**DRAINAGE REPORT
FOR**

Carpenter's Training Center

Prepared by:

**Tierra West, LLC
5571 Midway Park Place NE
Albuquerque, New Mexico 87109**

ENGINEER'S SEAL RONALD R. BOHANNAN P.E. #7868	CARPENTERS CENTER 3900 PAN AMERICAN FREEWAY	DRAWN BY BJF
	ANALYSIS POINT MAP	DATE 01/21/08
	TERRA WEST, LLC 5571 MIDWAY PARK PLACE NE ALBUQUERQUE, NM 87109 (505)858-3100	26026 ANALYSIS POINT MAP
		SHEET # C-1
		JOB # 26026

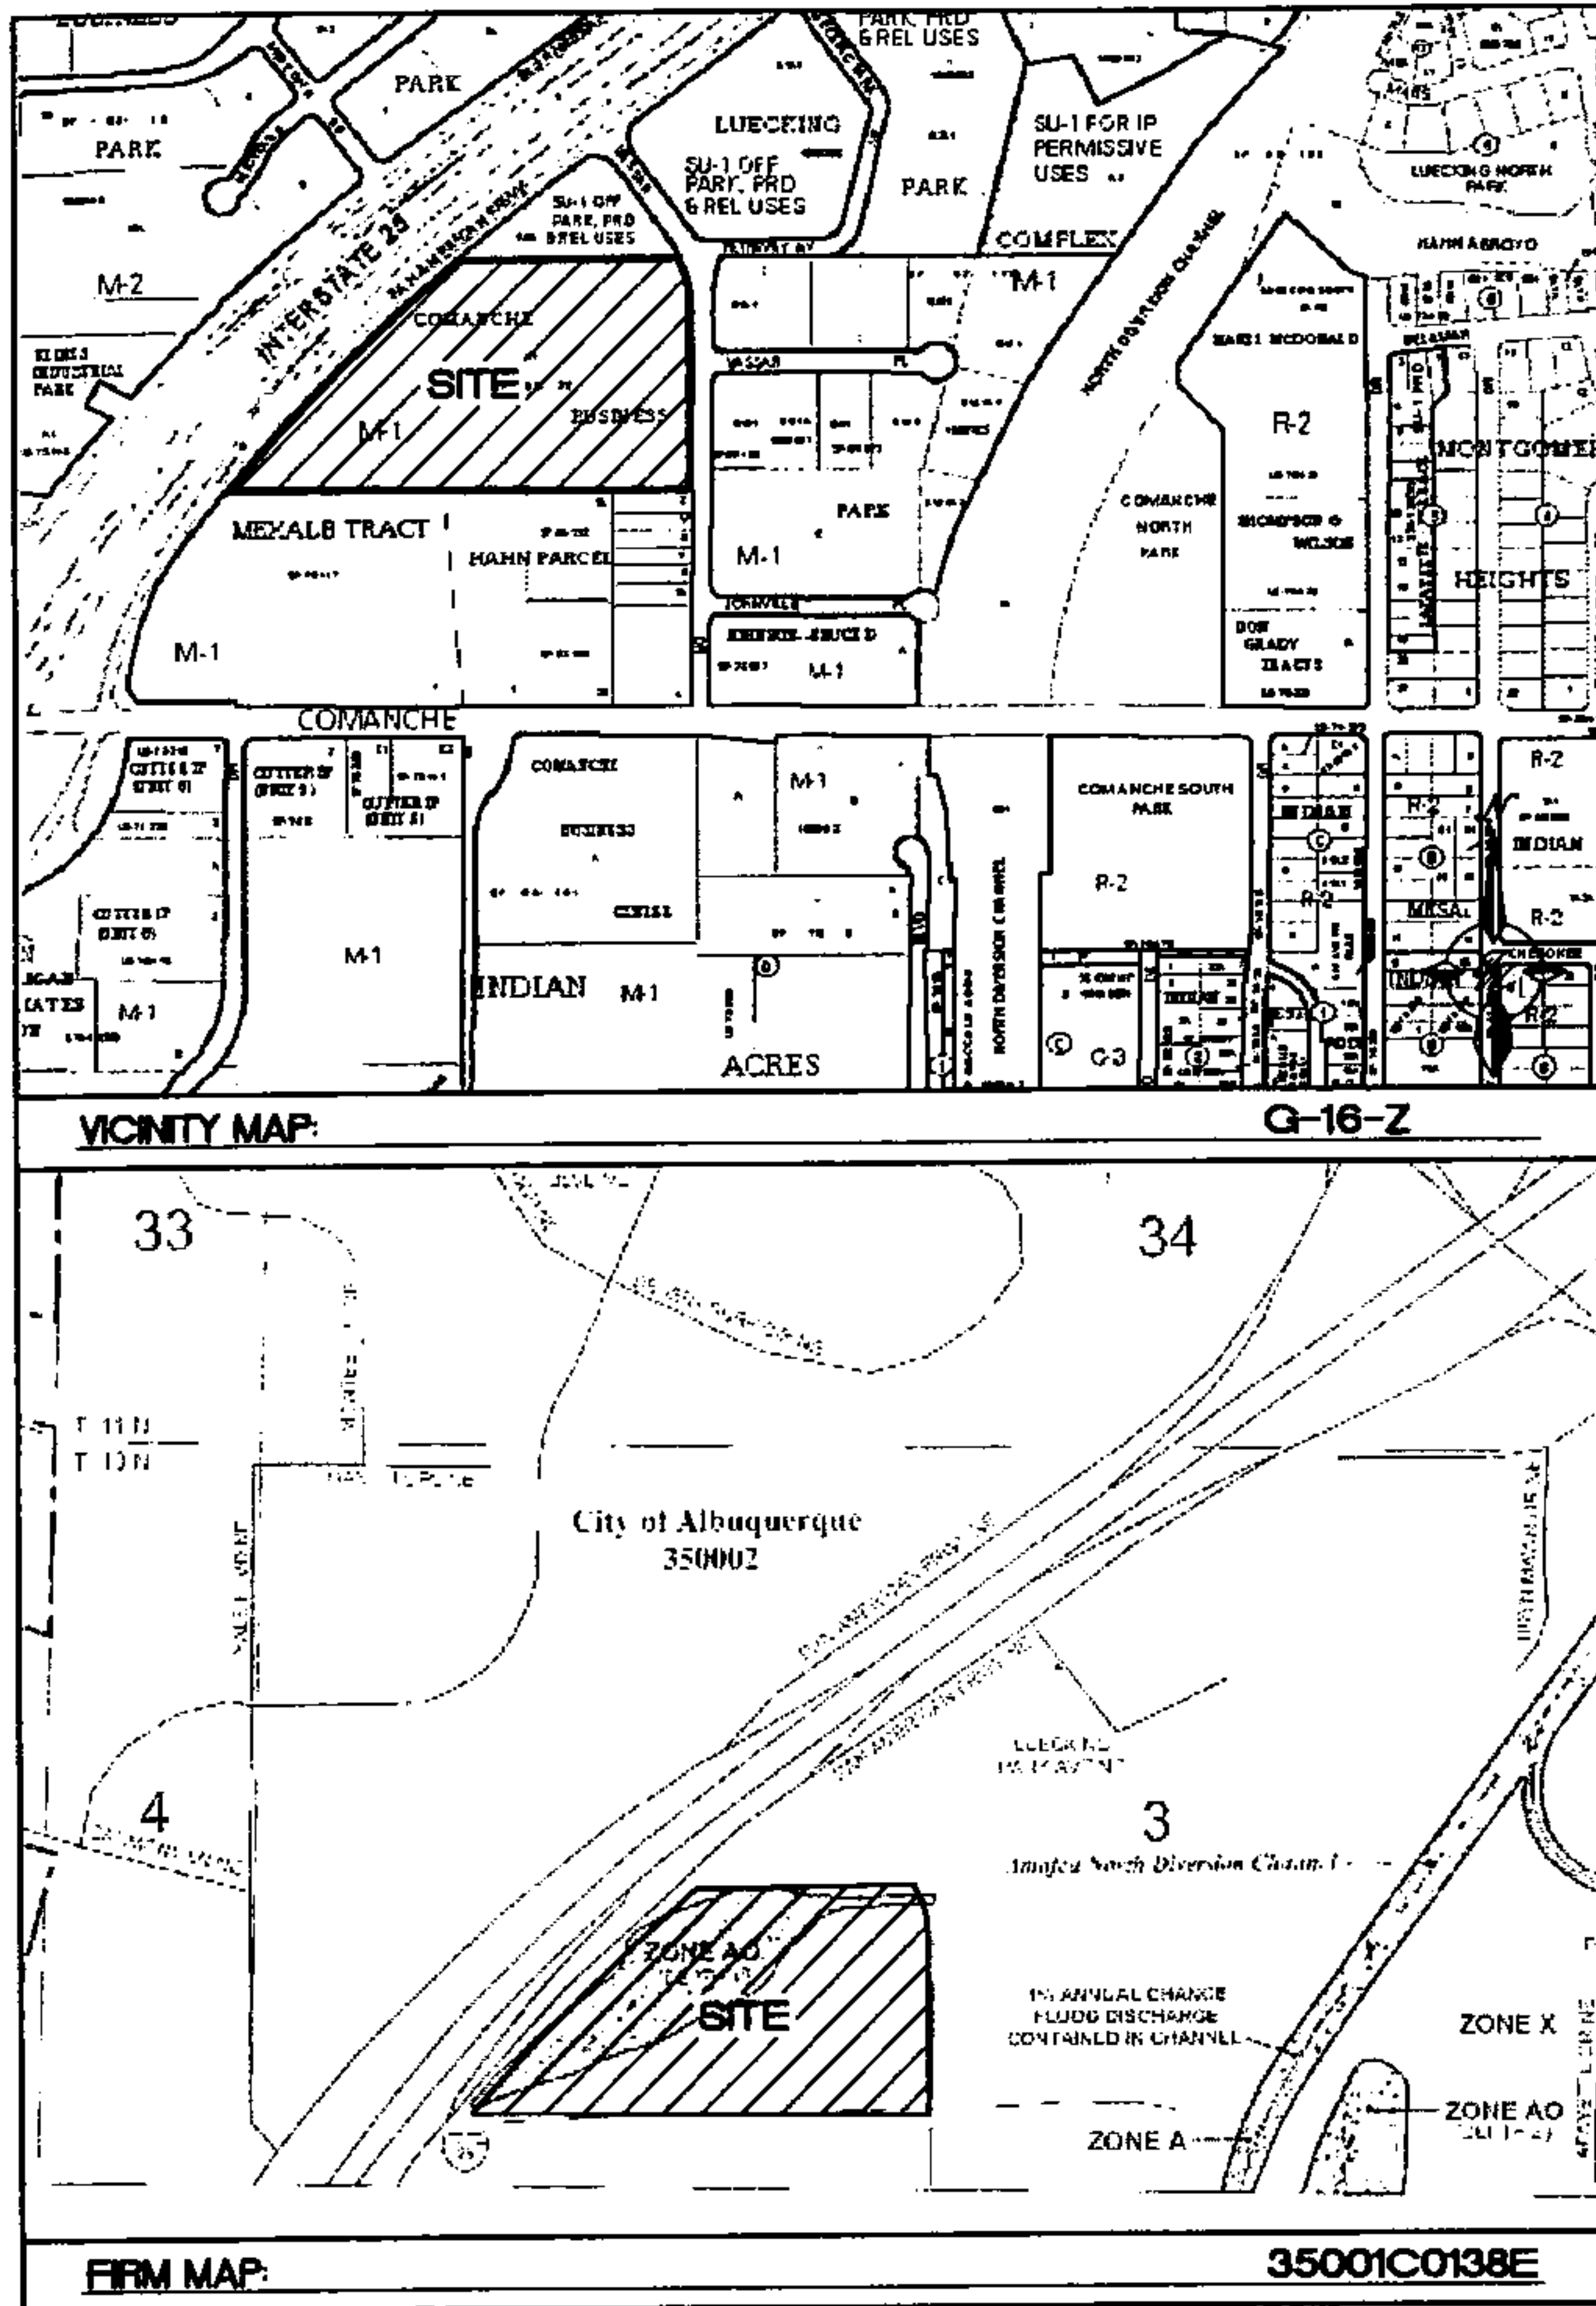
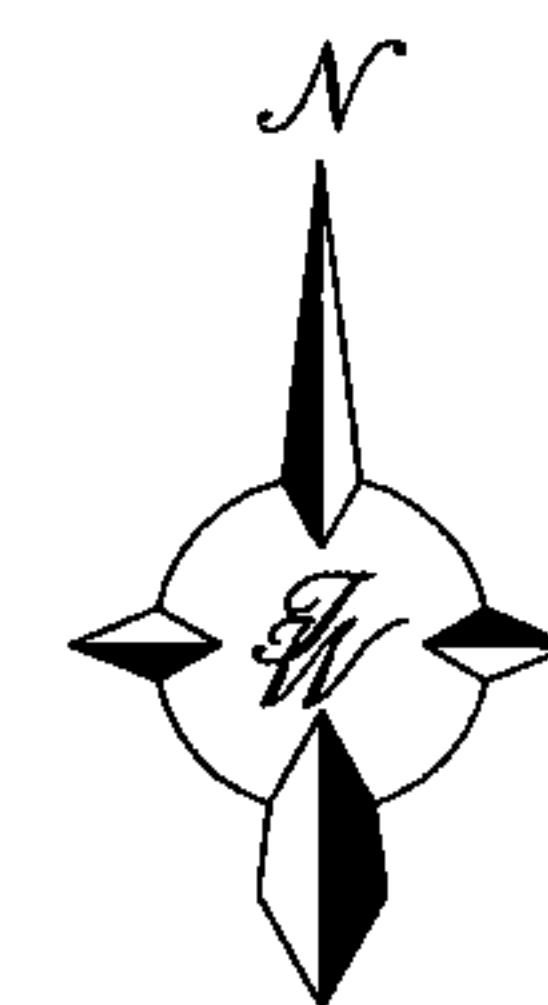
2. Please add a column to our pipe capacity table to provide contributing basins and analysis points so I can track your on-site storm drain design. Provide Table 1 of the SAD 216 report to justify allowable discharge at the 2 analysis points.
A column was added to the pipe capacity table to provide the contributing basins and analysis points to help track on-site storm drain design. Table 1 of the SAD 216 is included for reference.

Revised Pipe Capacity

R30	MH 12 to Existing 42" Stub	42	1	9.62	0.875	100.88	93.40	9.71	Upland Basin
R31	MH 12 to MH 13	24	5	3.14	0.500	50.72	24.50	7.80	Upland Basin
R29	MH 11 to ex. Culvert	48	1.4	12.57	1.000	170.42	146.89	11.69	Upland Basin + 15,16,17,18,19, 1A
R27	MH 7 to MH 11	24	1.4	3.14	0.500	26.84	19.49	6.20	15,16,17,18,19, 1A
